DOCKET 50-305  
OPERATING LICENSE DPR-43  
KEWAUNEE NUCLEAR POWER PLANT  
REVISION 21-B OF THE OPERATIONAL QUALITY ASSURANCE PROGRAM  
DESCRIPTION

Description of Revisions to the Kewaunee Nuclear Power Plant

Operational Quality Assurance Program Description

Revision 21-B

**Figure 1 Description of Change**

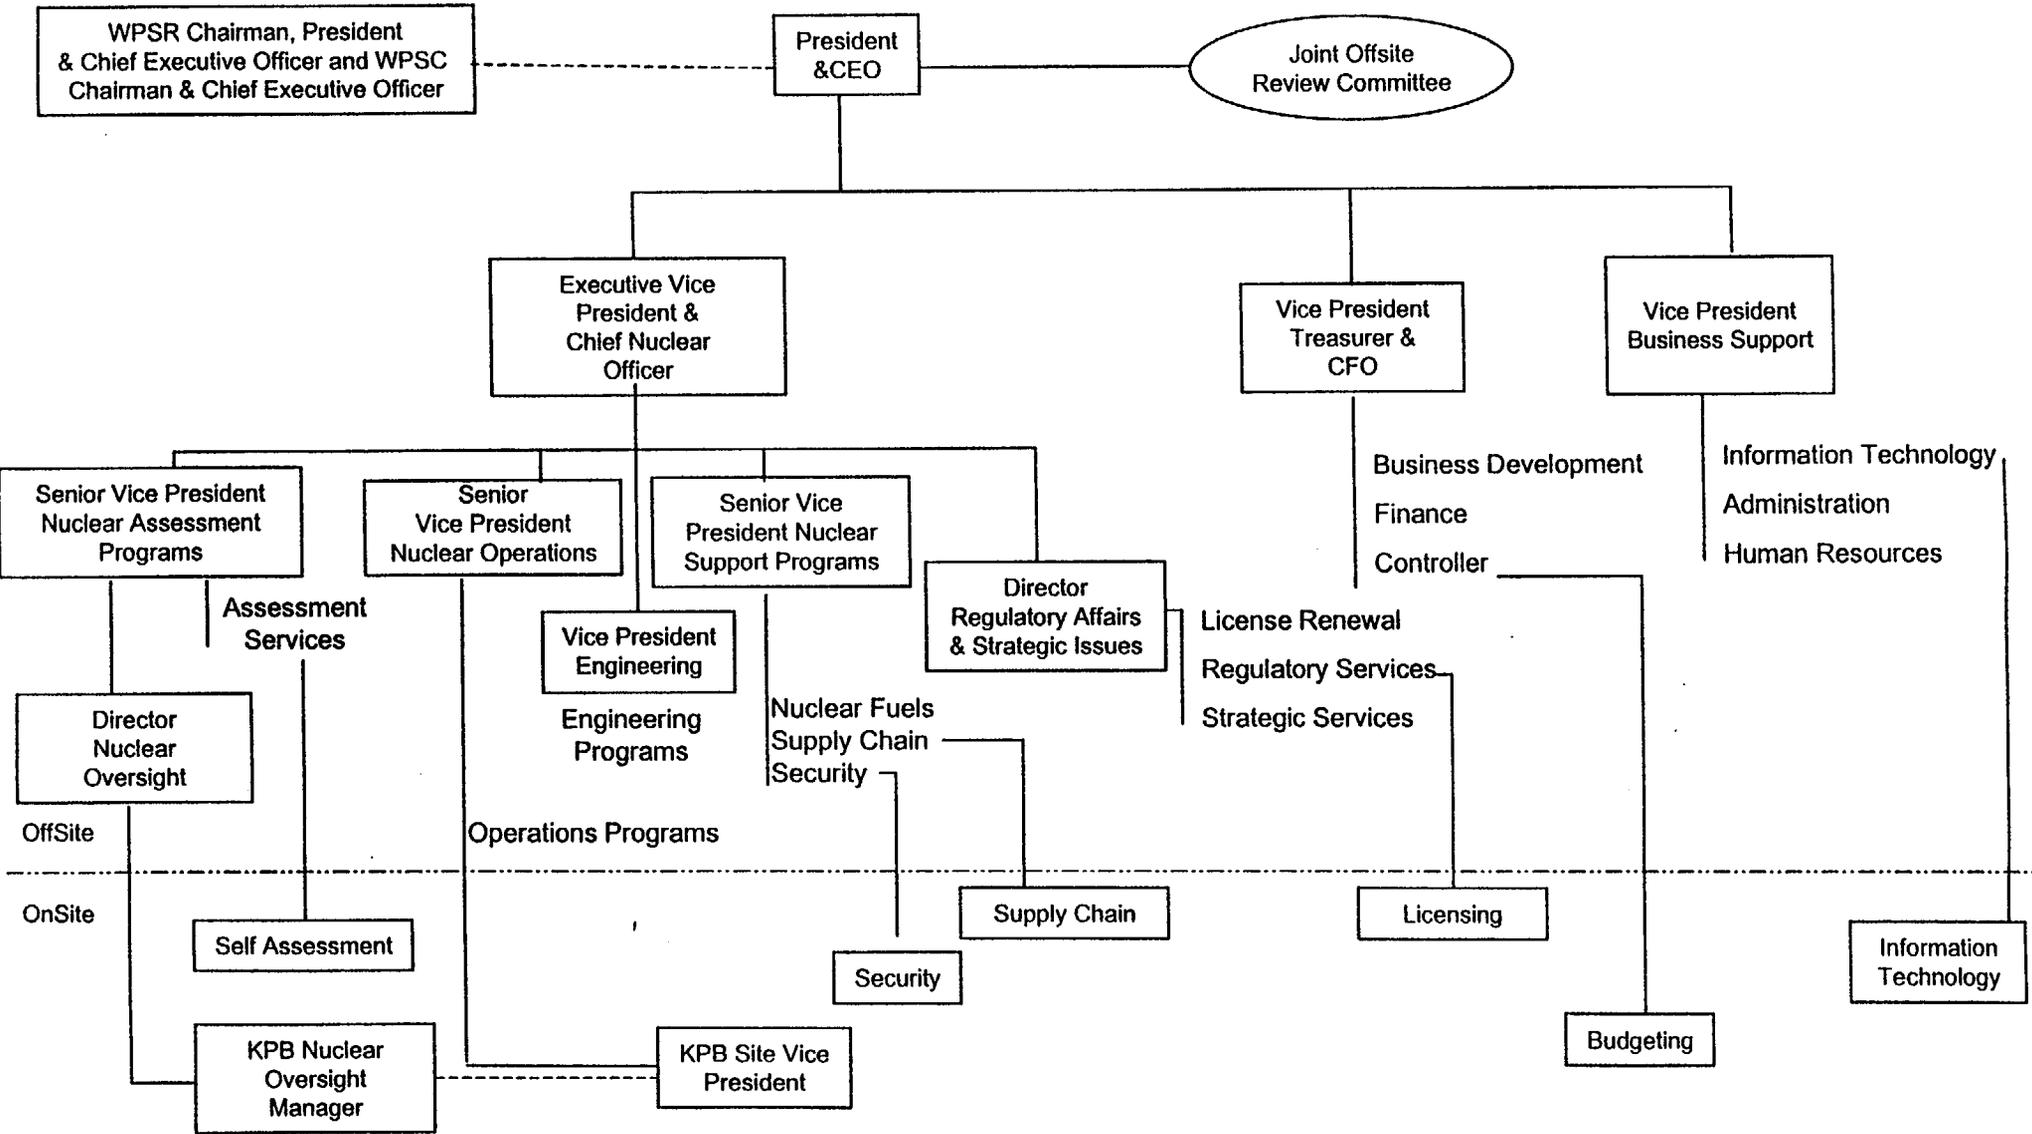
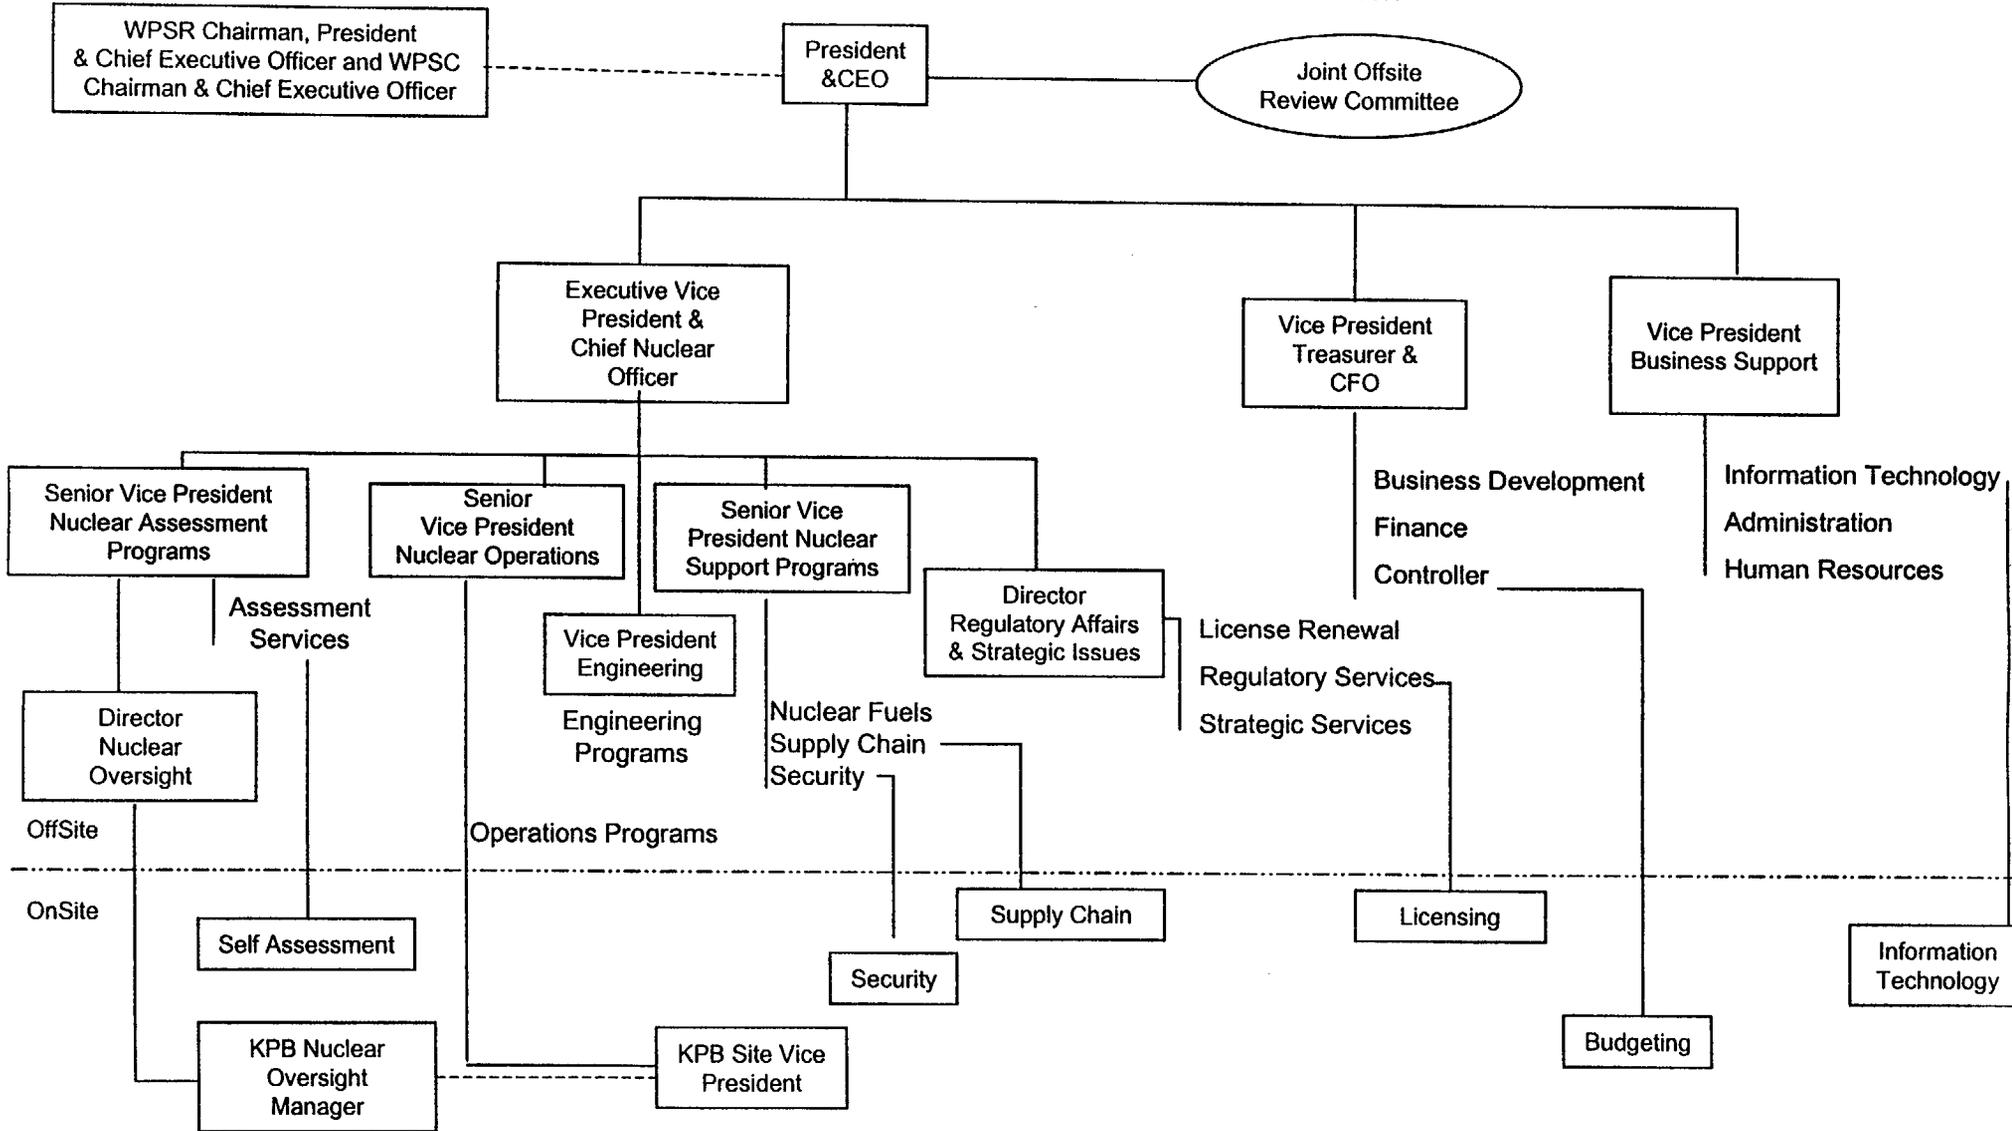
Change “Wpsc Chairman & Chief Executive Officer” to “Wpsr Chairman, President and Chief Executive Officer and Wpsc Chairman & Chief Executive Officer”  
Change “Senior Vice President & Chief Nuclear Officer” to “Executive Vice President & Chief Nuclear Officer”  
Change “Senior Vice President Assessment & Performance Improvement” to “Senior Vice President Nuclear Assessment Programs;” depict this position as reporting to the Executive VP & CNO.  
Change “Senior Vice President Operations” to “Senior Vice President Nuclear Operations.”  
Change “Vice President Operations (2)” to “Senior Vice President Nuclear Support Programs.”  
Change “Site Vice President” to “KPB Site Vice President”  
Change “Manager-Nuclear Oversight” to “KPB Nuclear Oversight Manager”  
Change “Director Regulatory Services & Strategic Issues” to “Directory Regulatory Affairs & Strategic Issues;” place this role under the Executive VP & CNO.

For the Vice President Business Support, delete the responsibility for “Communications.” It is not necessary to depict this.  
Depict “Information Technology” with a direct line to the on-site portion of the chart.  
Move the “Operations Programs” role under the Senior VP Nuclear Operations.

**Figure 2**

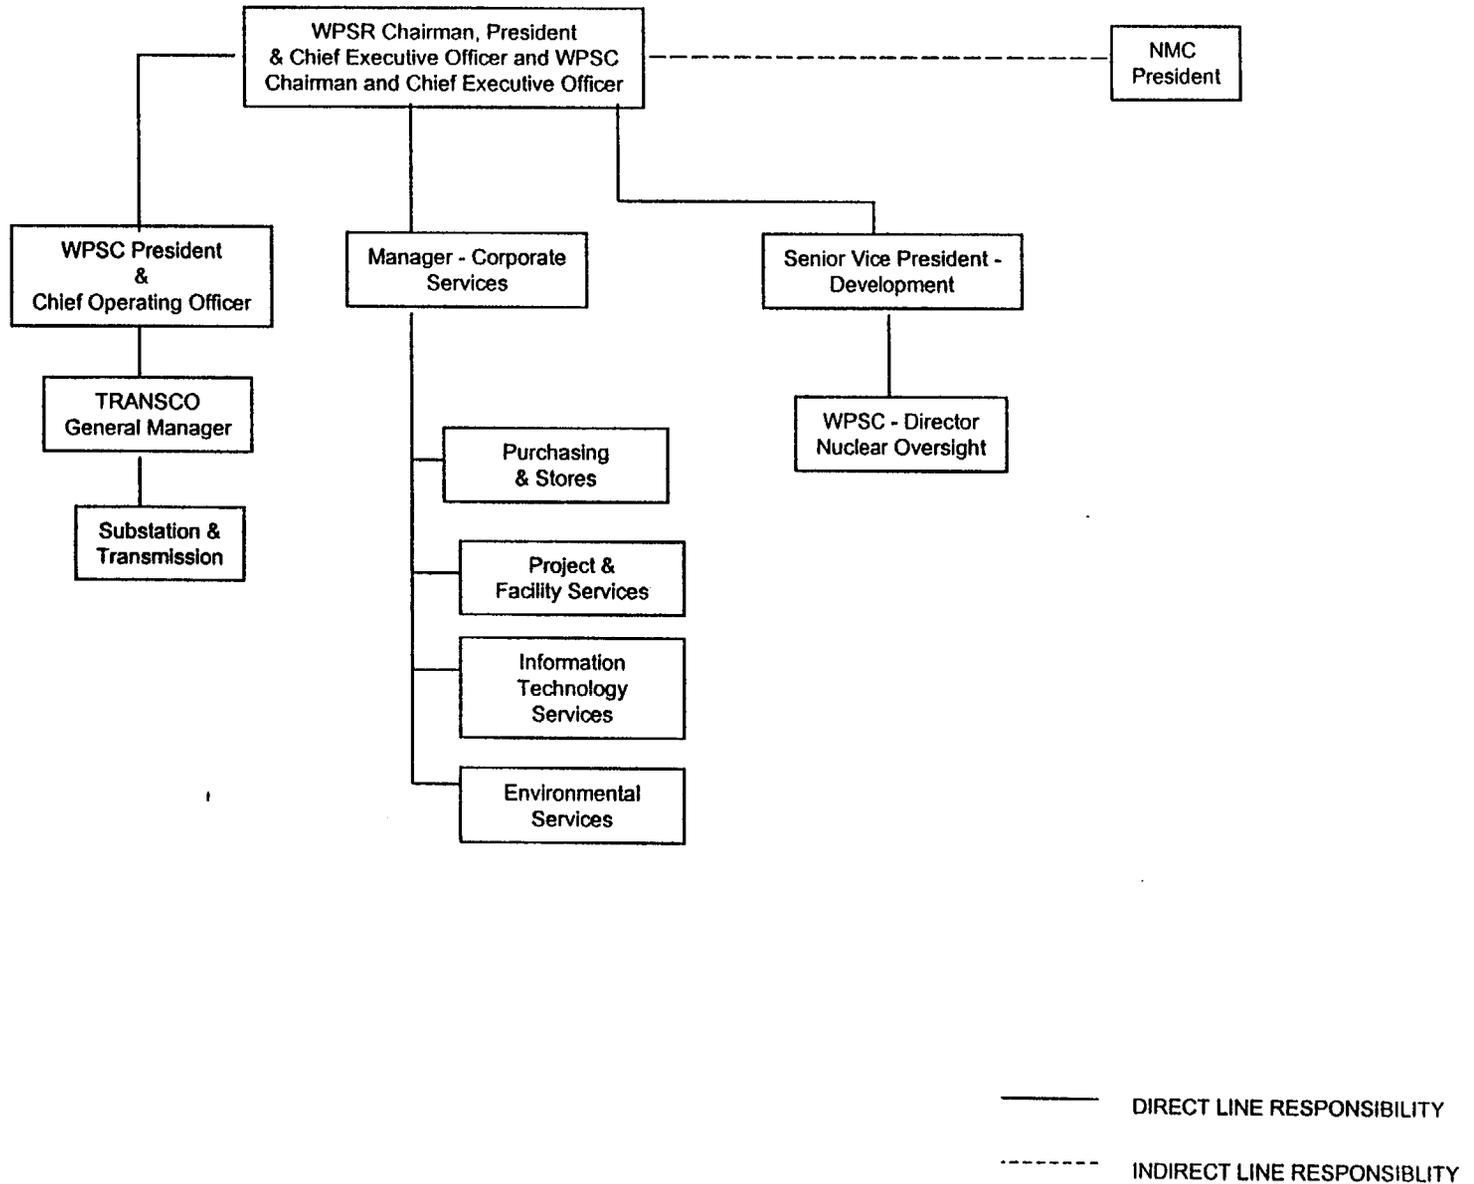
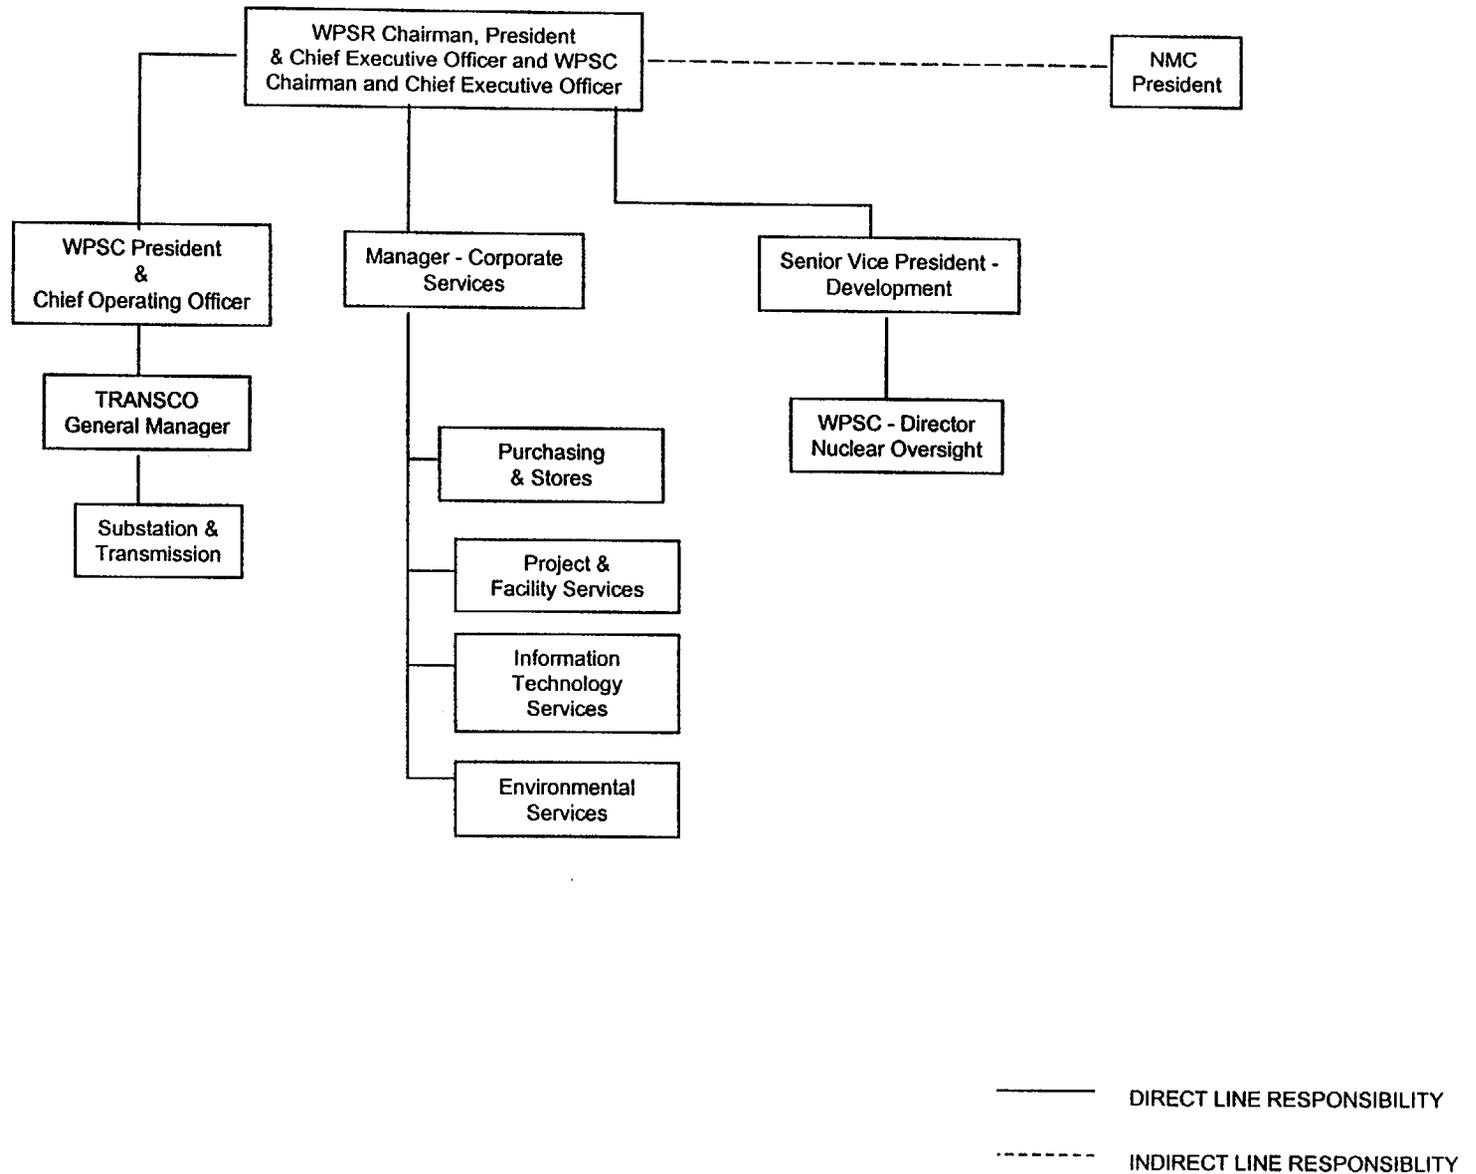
Change “WPSO Chairman & Chief Executive Officer” to “WPSR Chairman, President and Chief Executive Officer and WPSO Chairman & Chief Executive Officer”

Change the “Senior Vice President - Energy Supply” to “Senior Vice President – Development.”

**Figure 3**

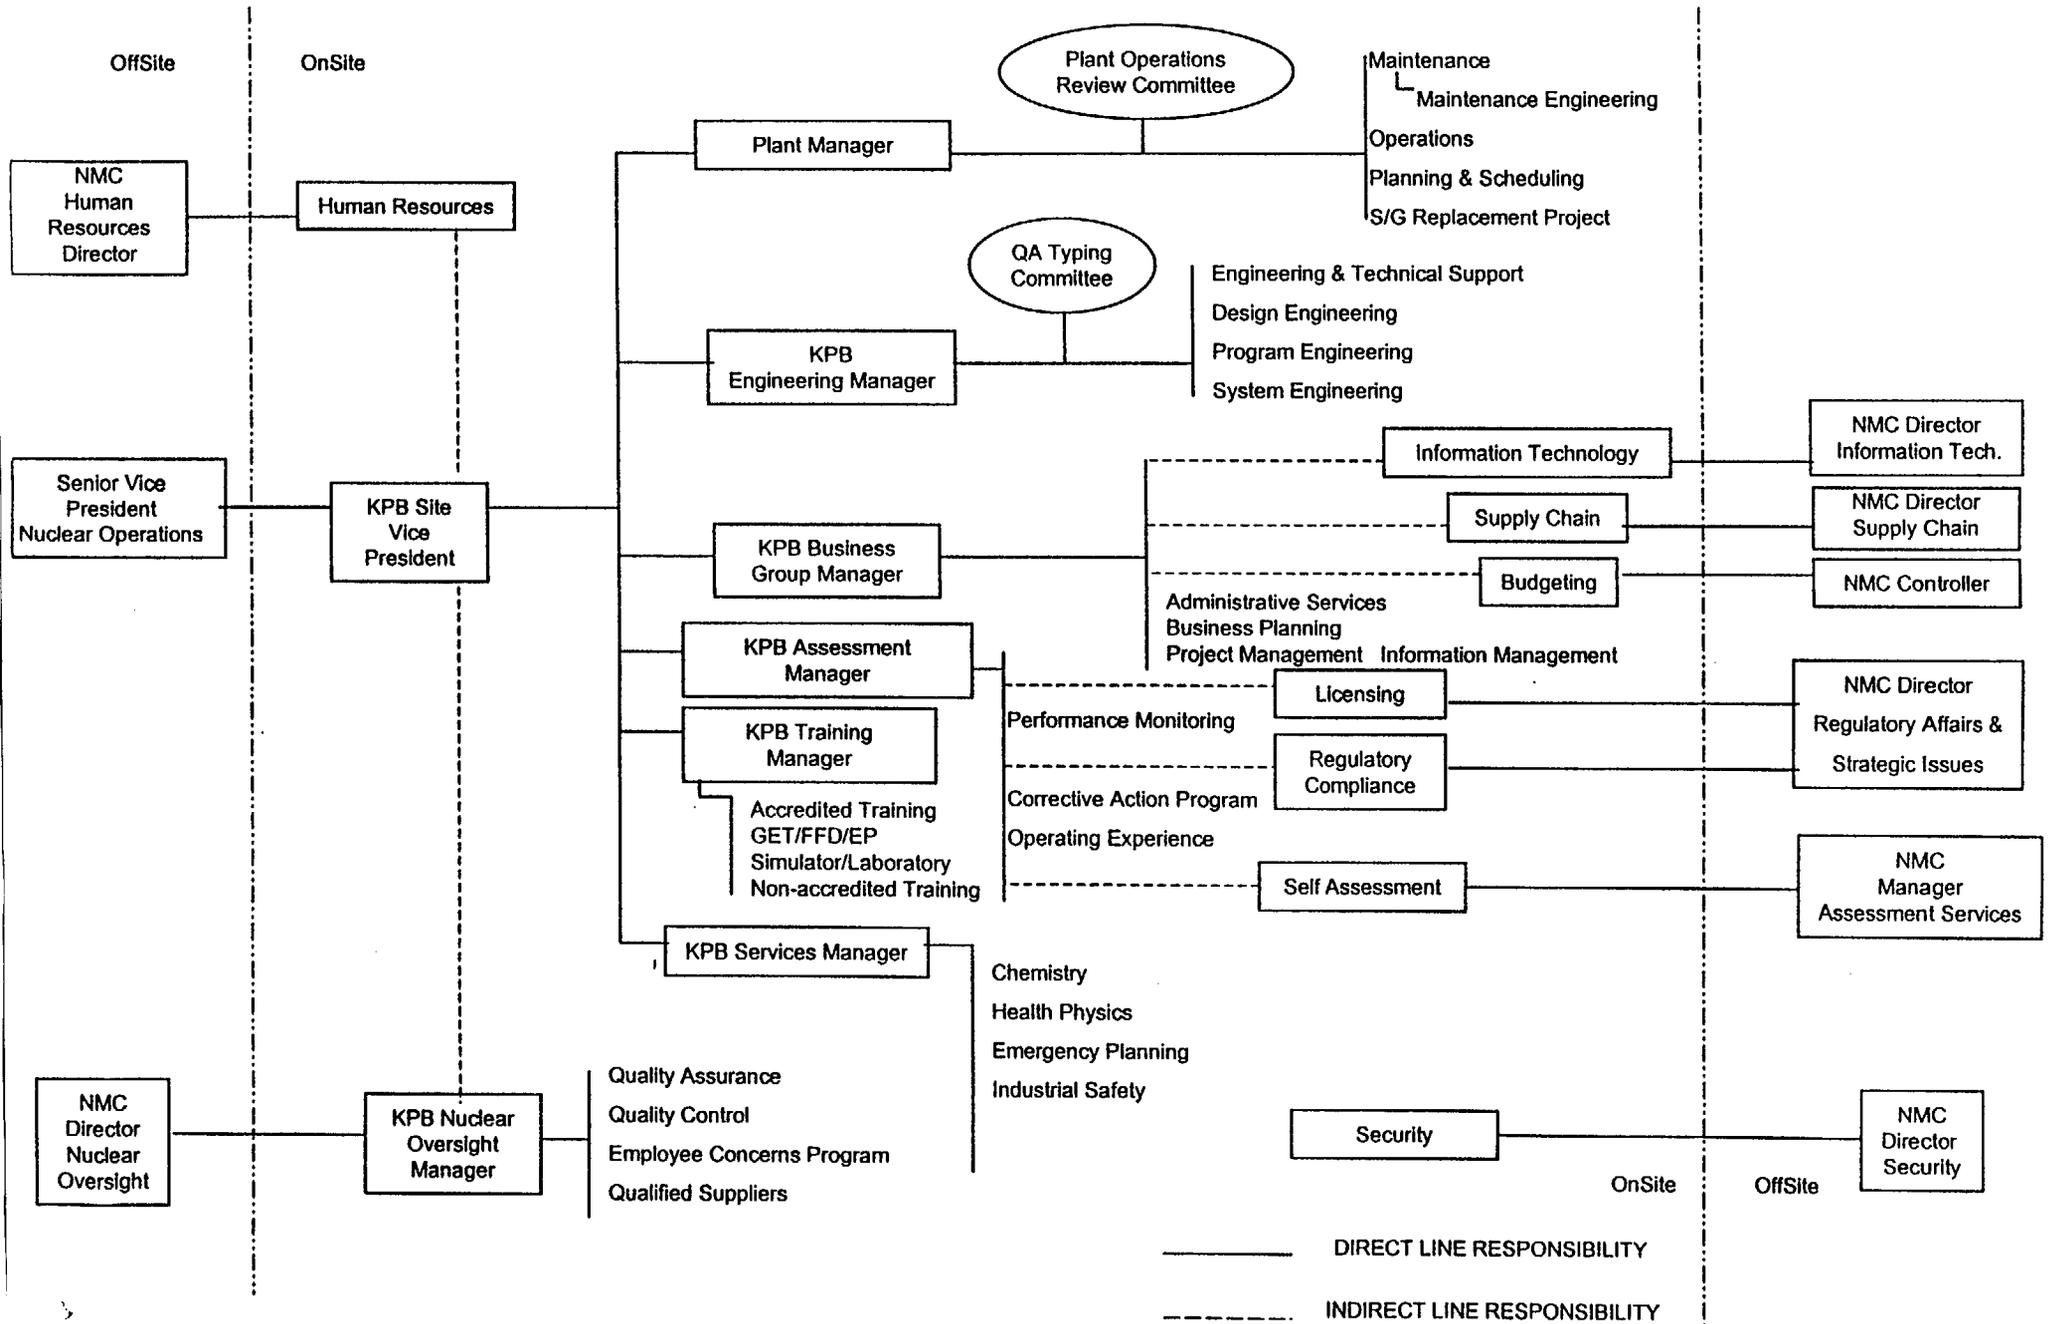
Change “Senior Vice President Operations” to “Senior Vice President Nuclear Operations”

Change the “Manager - Nuclear Oversight” to “KPB Nuclear Oversight Manager.”

Change “Site Engineering Director” to “KPB Engineering Manager.”

Change “Site Vice President” to “KPB Site Vice President”

Change “Site Business Manager” to “KPB Business Group Manager.”

Change “Site Assessment Manager” to “KPB Assessment Manager”

Change “Site Training Manager” to “KPB Training Manager”

Change “Site Service Manager” to “KPB Services Manager.”

Change “Manager-Nuclear Oversight” to “KPB Nuclear Oversight Manager”

Change “NMC Director Regulatory Services & Strategic Issues” to “NMC Director Regulatory Affairs & Strategic Issues.”
